HYUNDAI Technical Service Bulletin	GROUP CAMPAIGN	NUMBER 19-01-046H
	DATE DECEMBER, 2019	MODEL(S) PALISADE (LX2)
SUBJECT: BLIND-SPOT COLLISION WARNING (BCW) RADAR UPDATE (SERVICE CAMPAIGN T4K)

Applicable Vehicle: Certain 2020 MY Palisade (LX2) Equipped with BCW

BCW Malfunction Indicator Message

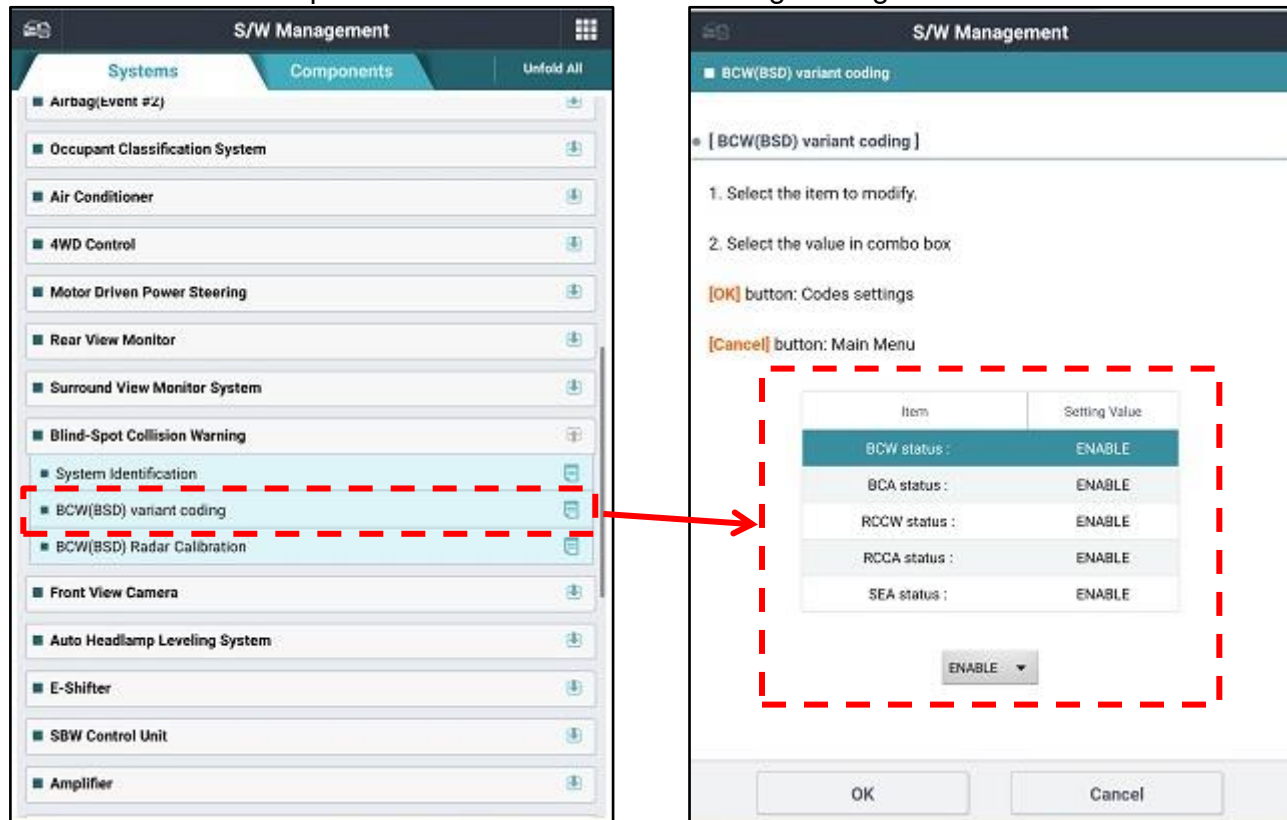
Description: Some Palisade (LX2) vehicles may intermittently experience the BCW Malfunction Indicator Light ON with a message "Check Blind-Spot Collision Warning System" displayed on the instrument cluster. When the BCW Malfunction Indicator Light is ON, the BCW function becomes inoperative. This bulletin provides the service procedure to update the BCW system software to correct the intermittent BCW Malfunction Indicator Light.

NOTE: When the BCW Malfunction Indicator Message turns ON, the diagnostic code C270354 (Control Module Slave Calibration) will be triggered.
